Problem Statement

MEITNER

Figure 1 The figure depicted above shows team MEITNER's understanding of the layout of the project from a birds eye view. We wanted to check bases and make sure our interpretation is correct.

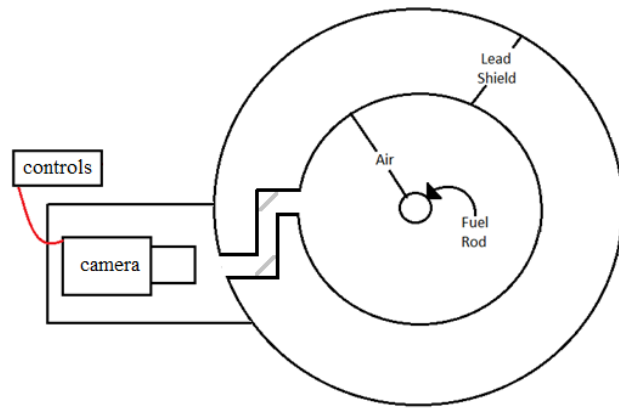
Commented [I14]: The through-hole will have to be meandering to provide a tortuous path such that there is no direct line of sight through the radiation shielding. The drawing has been edited to depict such a through-hole with mirrors at the bends to allow visual inspection.
